# How to update T32MZ

This software updates or alters the functions and features noted below. The instructions and information that follow are meant as a supplement to the original instruction manual that accompanied the T32MZ transmitter. Please refer to the original instruction manual where applicable, but replace the steps indicated below with these instructions. Please note that the software update will be finalized the first time that the T32MZ is powered up, after the software has been applied. As such, it may require a few moments before the Start screen appears. Please check to ensure that the update has been installed.

# 1. Add DLPH-2 setting function.

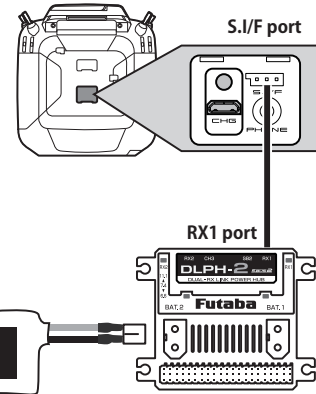
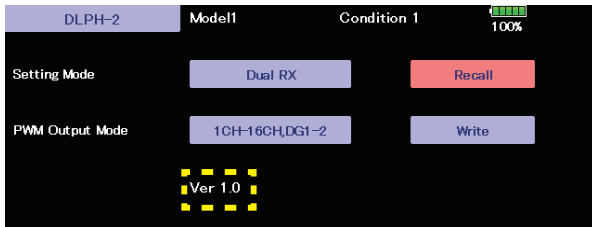
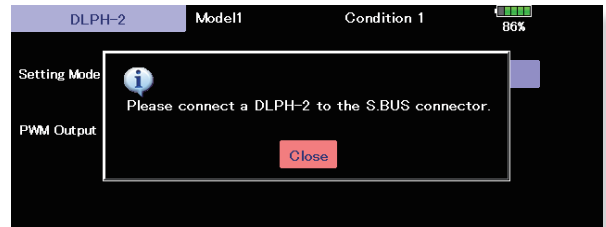
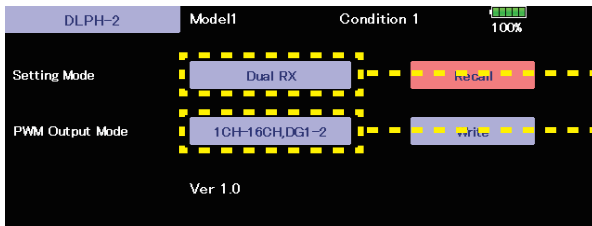
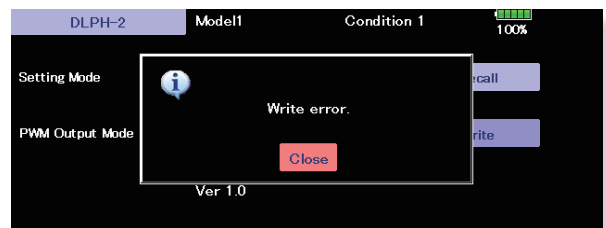
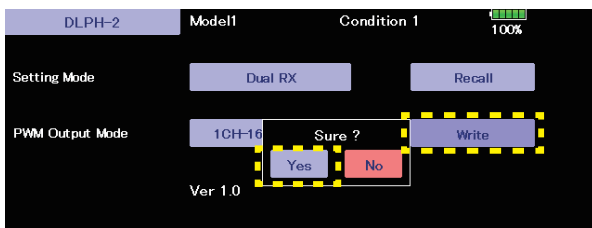
DLPH-2 mode setting can be performed on the T32MZ screen by wiring the DLPH-2 as shown in the figure.

1. Connect DLPH-2 to the transmitter as shown in the diagram on the right.
2. Call the **System menu** → **DLPH-2** screen.
3. Tap **Recall**

4. The version of the connected DLPH-2 will be displayed.

5. Configure the DLPH-2 mode settings.

When setting mode is set to **[Airplane Gyro]**, PWM output mode is fixed to **[1CH-16CH, DG1-2]**.

6. Tap "Write", a confirmation screen will appear. Tap "Yes" to write the setting value to DLPH-2.

## 2. Add Receiver setting function.

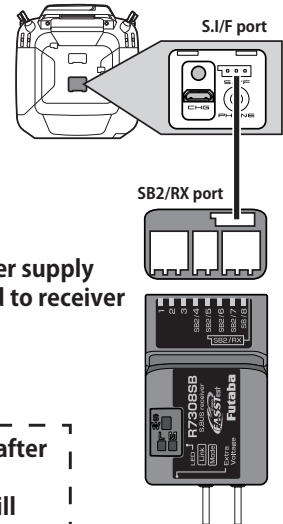
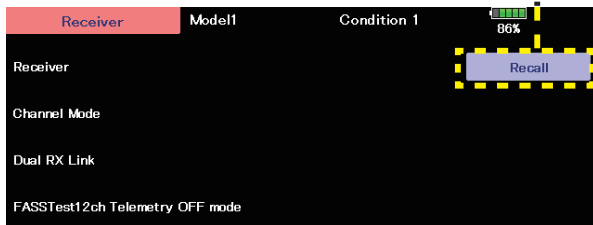
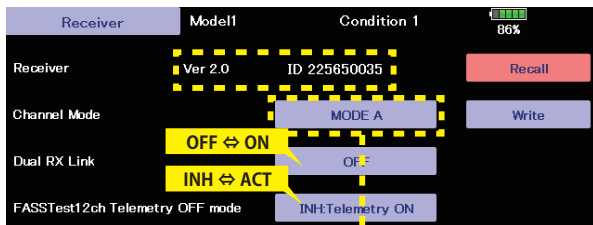
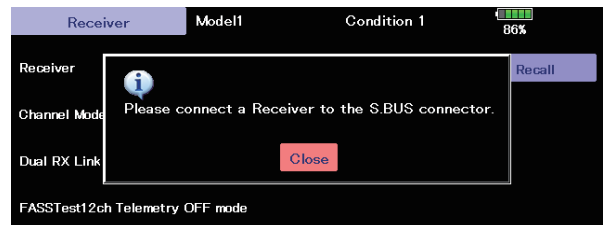
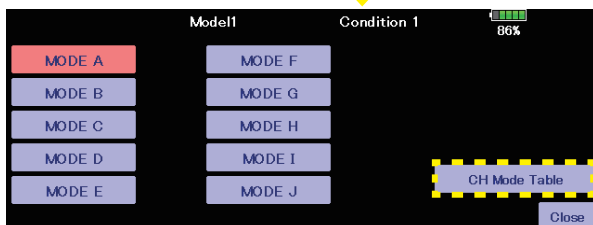
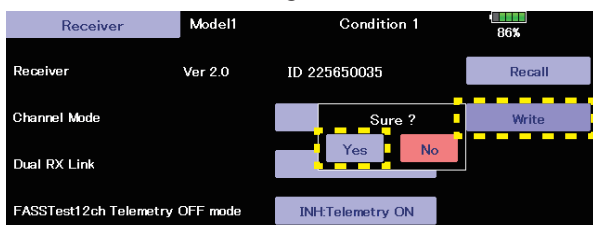
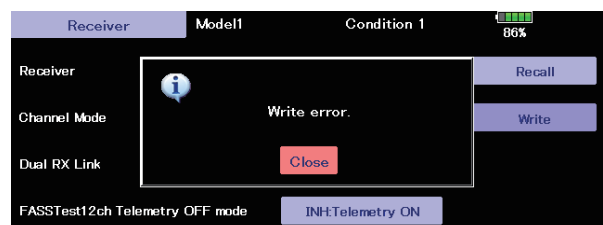
Receiver mode setting can be performed on the T32MZ screen by wiring the receiver as shown in the figure.

3. Connect receiver to the transmitter as shown in the diagram on the right.

4. Tap **Recall**

5. The version/ID of the connected receiver will be displayed.

6. Tap **Channel Mode** to set the receiver mode.

7. Tap "Write", a confirmation screen will appear. Tap "Yes" to write the setting value to receiver.

## 1. Telemetry settings: Added gear ratio setting button to Kontronik ESC and Scorpion ESC.

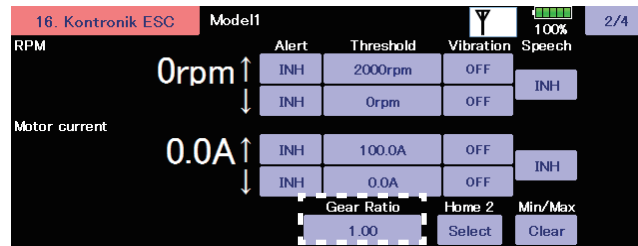
•If the gear is down, enter the gear ratio to display the helicopter rotor speed and the airplane gear down propeller speed.

## 2. Telemetry settings: Changed the motor pole number setting for each ESC to "100".

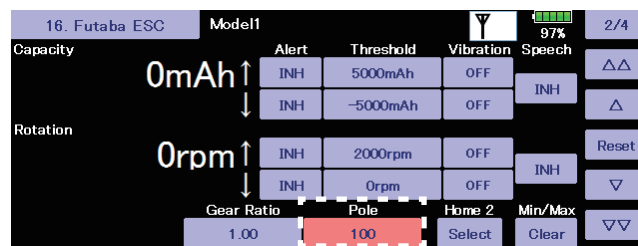
Previously, the number of poles was up to 36, but now it can be set up to 100.

•Enter the number of poles for your motor.

# 1. GYA553 New firmware Version 2.x support. → Refer to T32MZ GYA553 V2 Setting manual

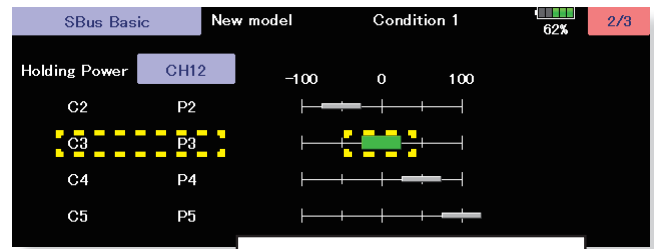
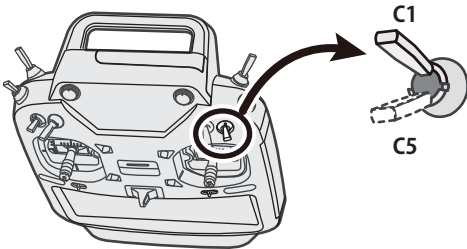
- 1. CH3 (THR) can be output to the RUD2 / S.BUS2 port.
- 2. The Holding Power rate of the aircraft in AVCS mode has been expanded to 5 types from C1 to C5, and each rate can be set by switching the display.
- 3. Added the setting of switching CH of Holding Power rate C1 to C5 to S.BUS basic menu.

Like the flight condition function of the transmitter, you can set up to 5 different data for the attitude holding force rate of the aircraft in AVCS mode by operating the switch from the transmitter, and switch between them. You can set the holding power rate selector switch to the channel with the AFR function of the transmitter, and set the point for each rate on the AFR point curve to switch. It is also possible to use the flight condition function to work with the flight condition switch.

## 2. Add R.P.M. display : Gov Basic

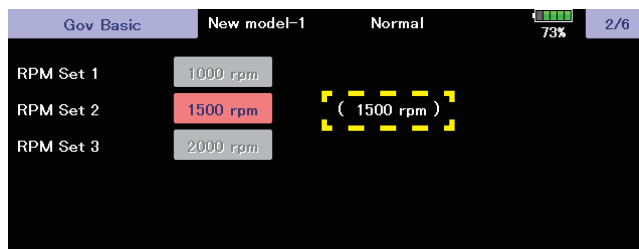
The number of revolutions of the governor setting is displayed on the governor basic screen of the gyro setting.

## 3. GYA553 Addition of setting parameters

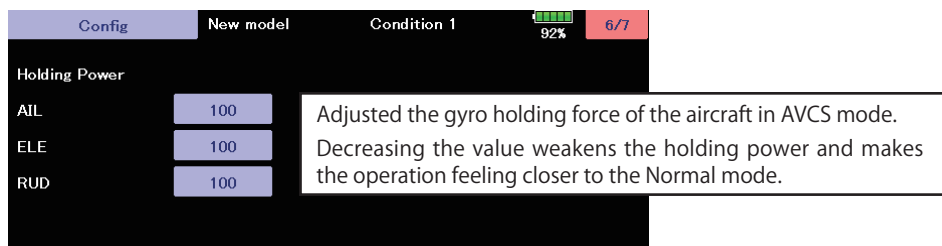
AIL / ELE / RUD holding power setting has been added to the setting parameters of GYA553.

## 4. Expansion of governor R.P.M. range

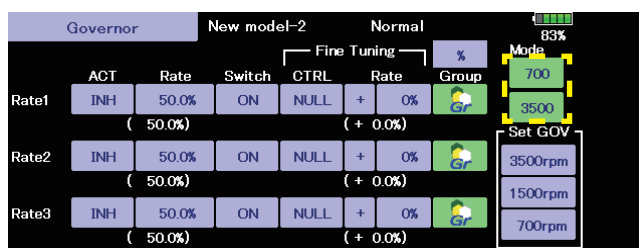
With the governor function of the model menu, the R.P.M. range has been expanded to 700 to 3500 rpm.

### 1. Add Screen off function [Quick start]

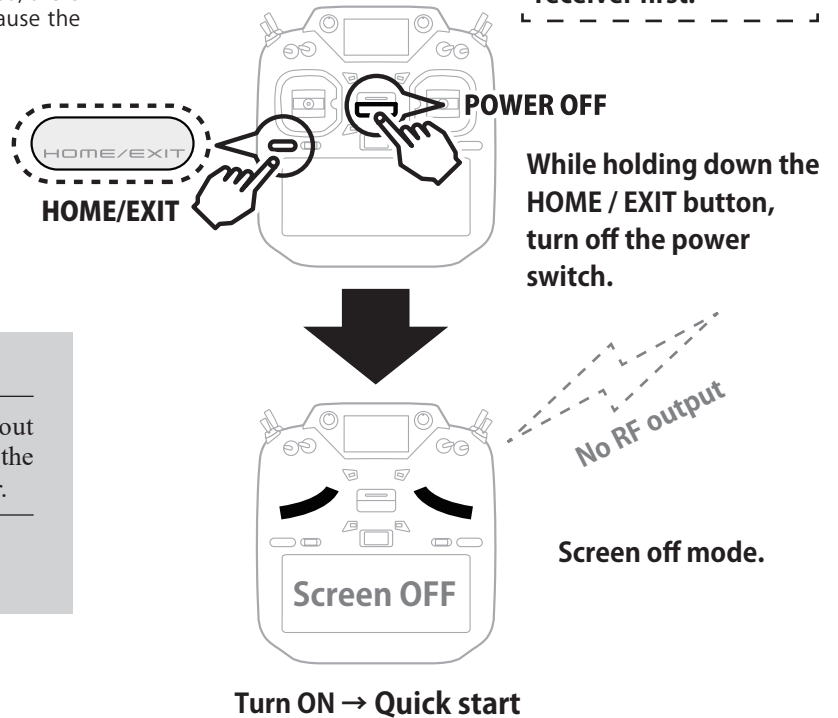
This "screen off" can quick start next startup. This is convenient when turning on and off frequently. No RF output at "screen off". Also, there is no screen display. However, the battery is consumed because the internal circuit is activated.
